Ref: Pierpont ATC Deferred Maintenance

Subj.: ADDENDUM BULLETIN NO. 1

WVCTCS Pierpont ATC Deferred Maintenance Projects

SCALE: 3/8" = 1'-0" SHEET: A-4.1

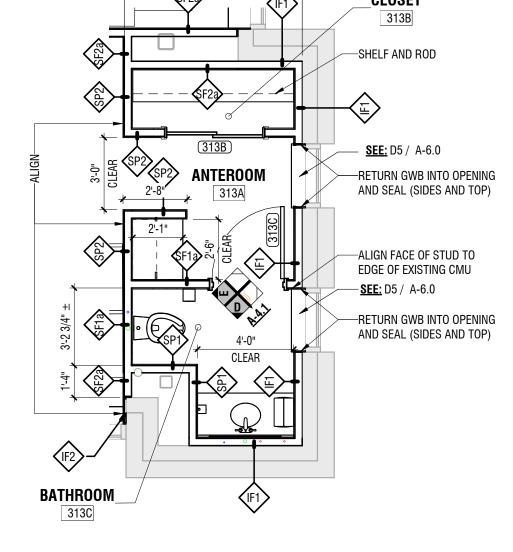
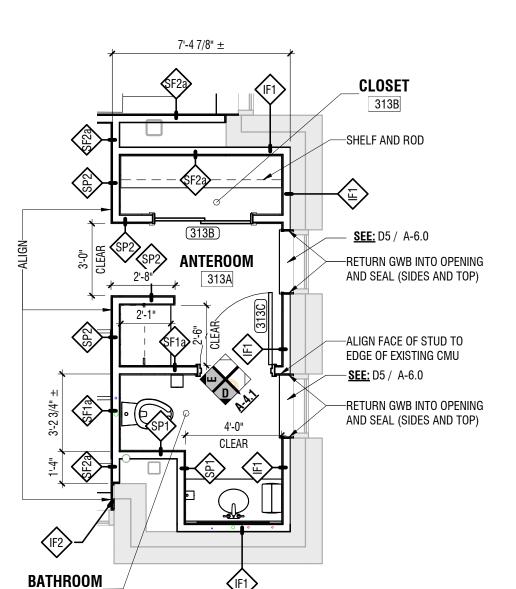
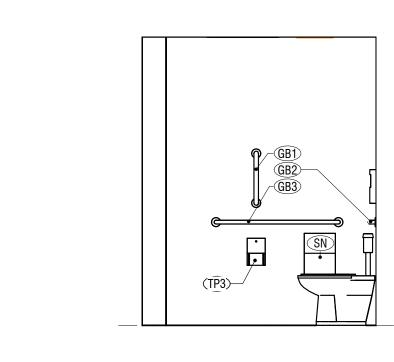
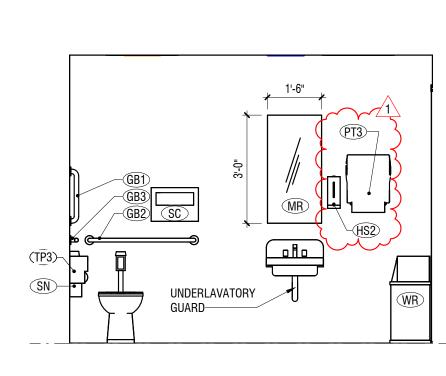
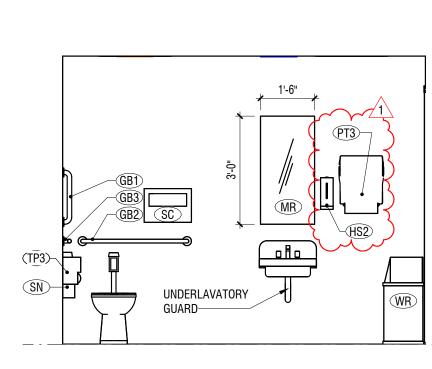
- a. **Drawing A-4.1:** REPLACE sheet in its entirety, see Enclosures. Updates have been clouded and tagged. Revisions relate to labeling of toilet accessories.
- b. **Drawing A-7.0:** REPLACE sheet in its entirety, see Enclosures. Updates have been clouded and tagged. Revisions relate to type and location of wall finish materials.

| Question Number | Question | Response | In Addendum |
|--------------------|--|--|-------------|
| 004 | Is the PT2 on A-4.1 NIC- by owner? | This label should read "PT3", see Addendum No. 1 for revised sheet. | 1 |

PT3 PAPER TOWEL DISPENSER (AUTOMATIC, ROLL TOWELS) - SURFACE MOUNTED (N.I.C. - BY OWNER)

01 03 THIRD FLOOR FINISH PLAN
SCALE: 1/8" = 1'-0" SHEET: A-7.0

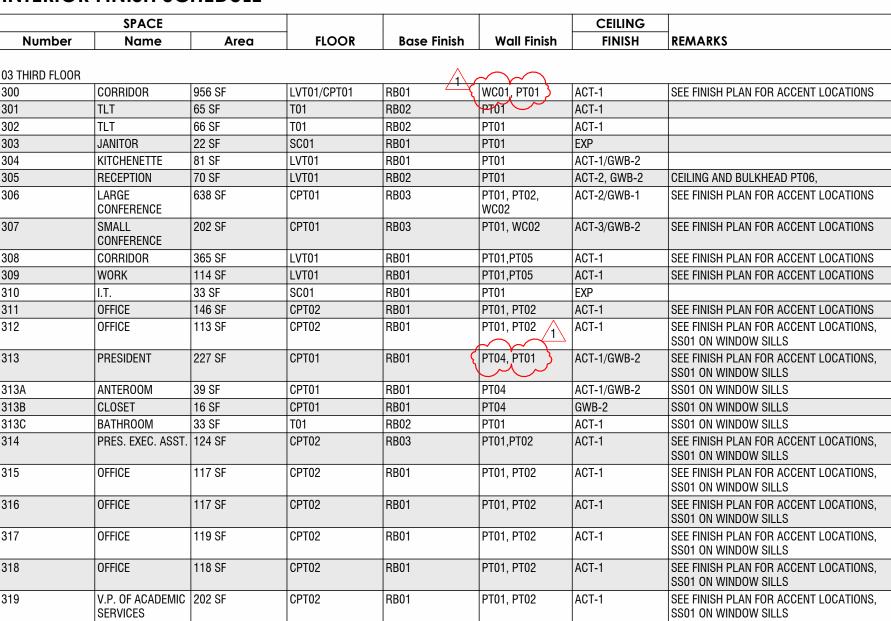
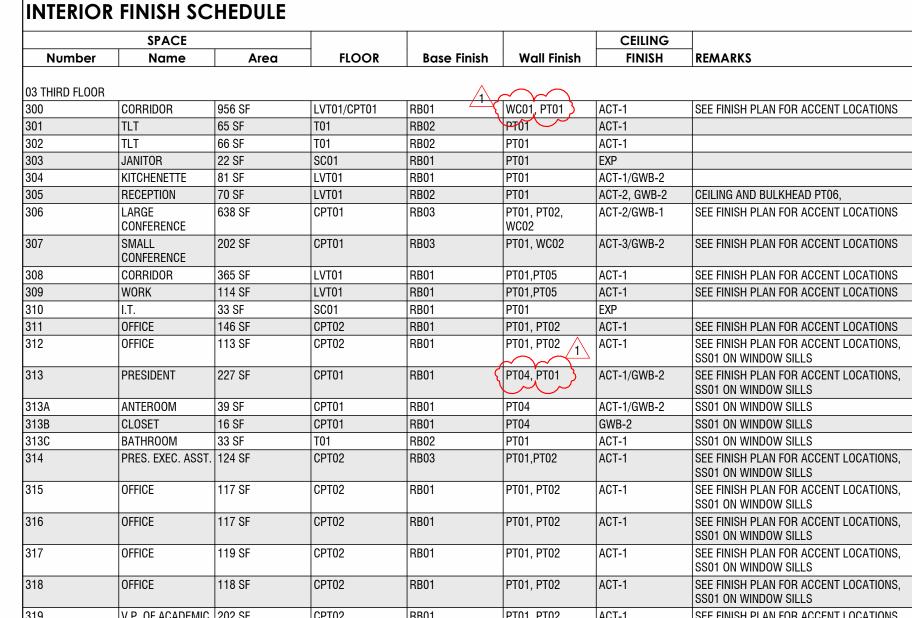
| Question Number | Question | Response | In Addendum |
|--------------------|--|--|-------------|
| 005 | Finish schedule on A-7.0 calls for WC01 in corridor 300 but there is no indicator on the finish plan. Please clarify | Labels and materials have been clarified. See revised sheet in Addendum No. 1. | 1 |
